REGION OF OTTAWA-
CARLETON

SUBJECT/OBJET **REVISED DRAFT PLAN CONDITIONS-
HISTORIC ELMWOOD COUNTRY LOT SUBDIVISION
TOWNSHIP OF WEST CARLETON**

That Planning and Environment Committee recommend that Council approve the revised draft conditions (attached as Annex A) for draft plan of subdivision 06T-98025.

CONDITIONS REVISED SEPTEMBER 2000, FOR OMB APPROVAL

DRAFT PLAN FOR HISTORIC ELMWOOD

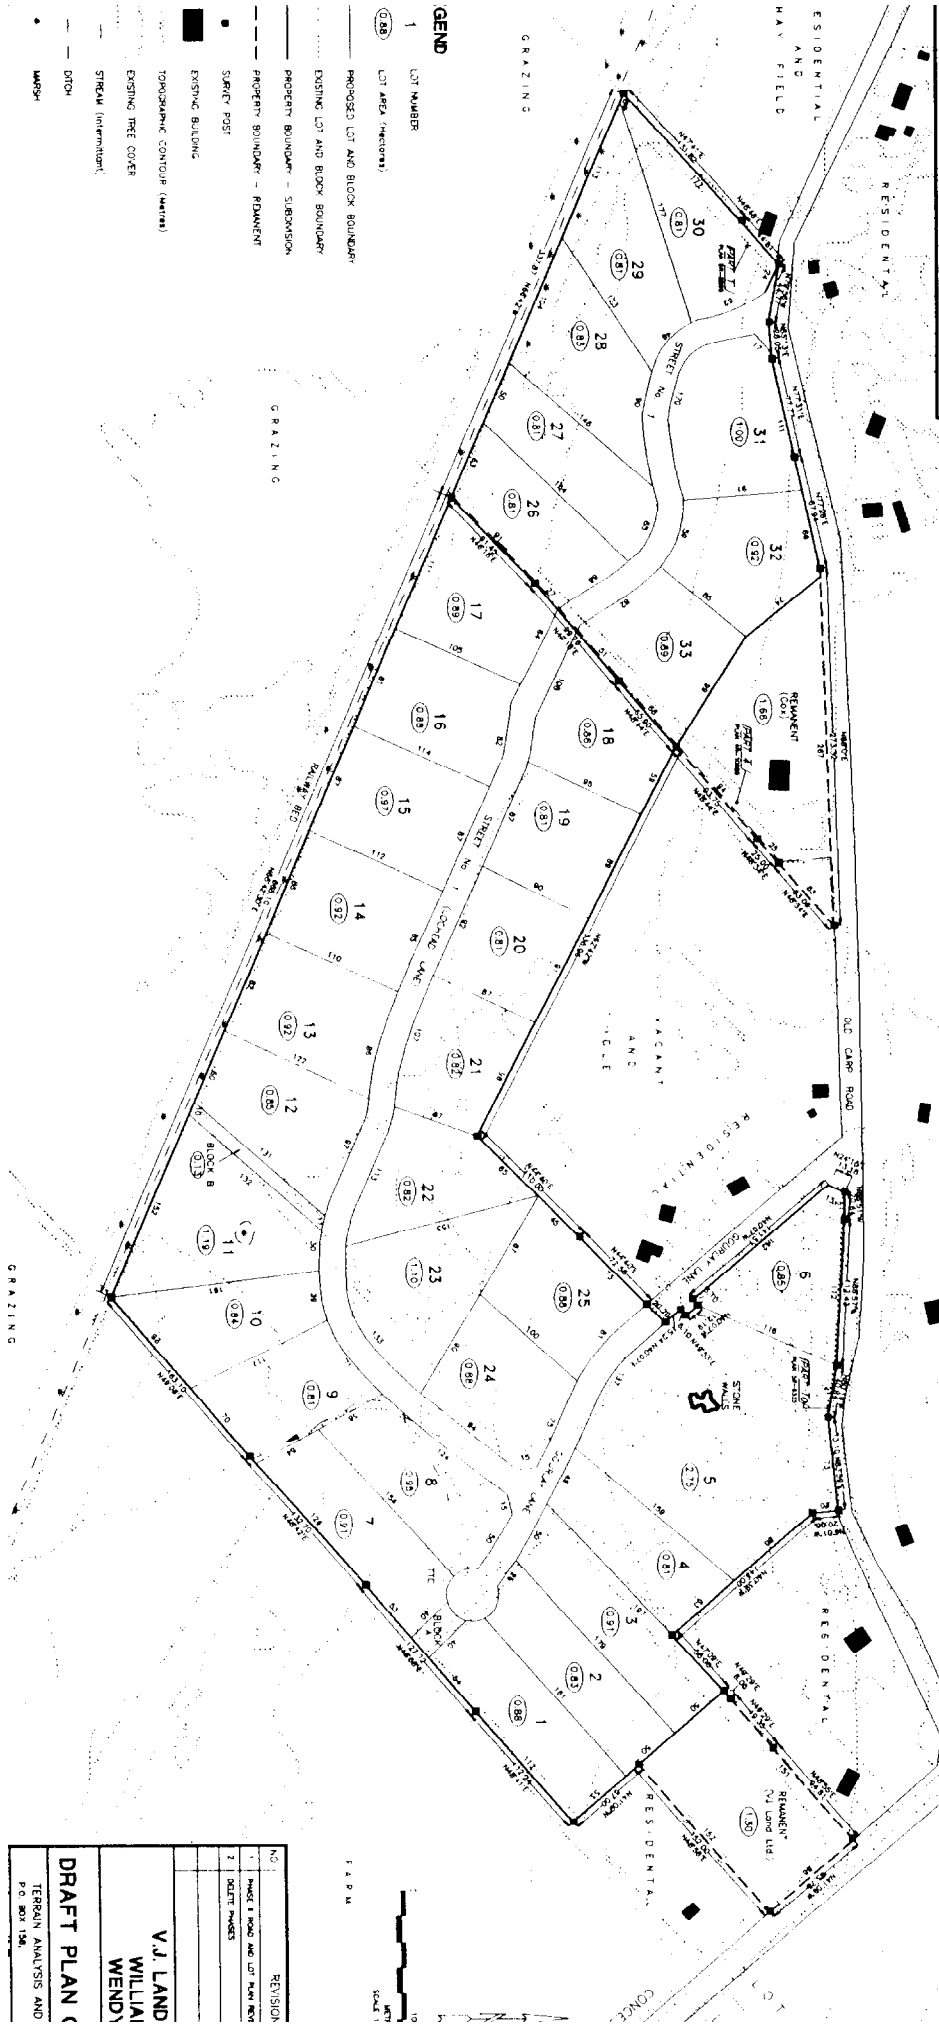
- Condition 1 be amended to include reference to the Blocks which are set aside for the future access to the Honeywell lands and to the railway, as shown on the revised plan as Blocks “A” and “B”
- Condition 2 be amended by adding the following to the end of the clause:

- Condition 11 be amended to accept Block “B” for access to the railway lands has been shown on the revised draft plan, and to change ‘Street No. 1’ to ‘Lohead Lane’

1. This approval applies to the draft plan certified by, OLS, dated 29 January 1999, as amended on 26 June 2000 showing 33 residential lots, 1 Block for future road purposes and 1 block to provide a pathway to the railway.

Re: Historic Elmwood Subdivision

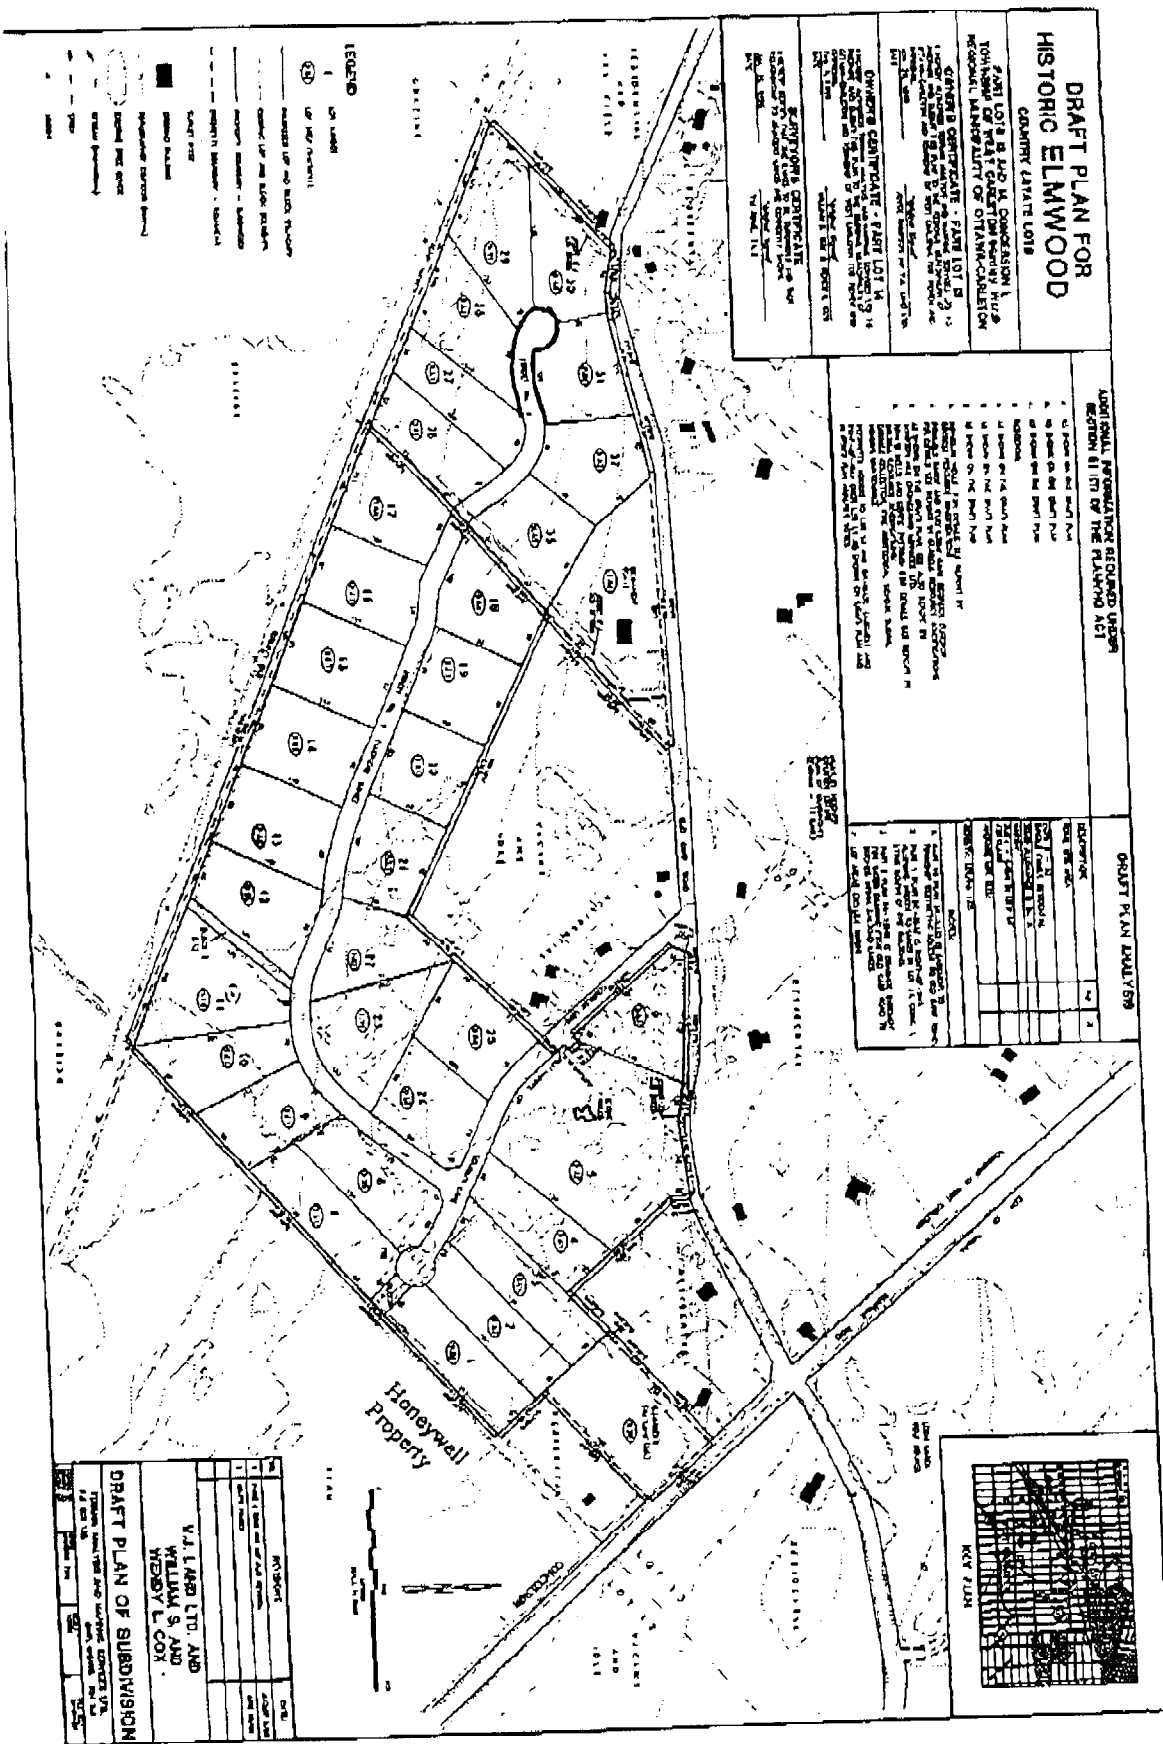
Please consider the cul-de-sac option at the west end of Lockheed Lane (Schedule A) rather than a 3 way stop intersection at the Old Carp Rd. (Schedule B).

Any health and safety benefit gained by having a second access would be grossly overshadowed by the health and safety hazard that you would create with this dangerous intersection.
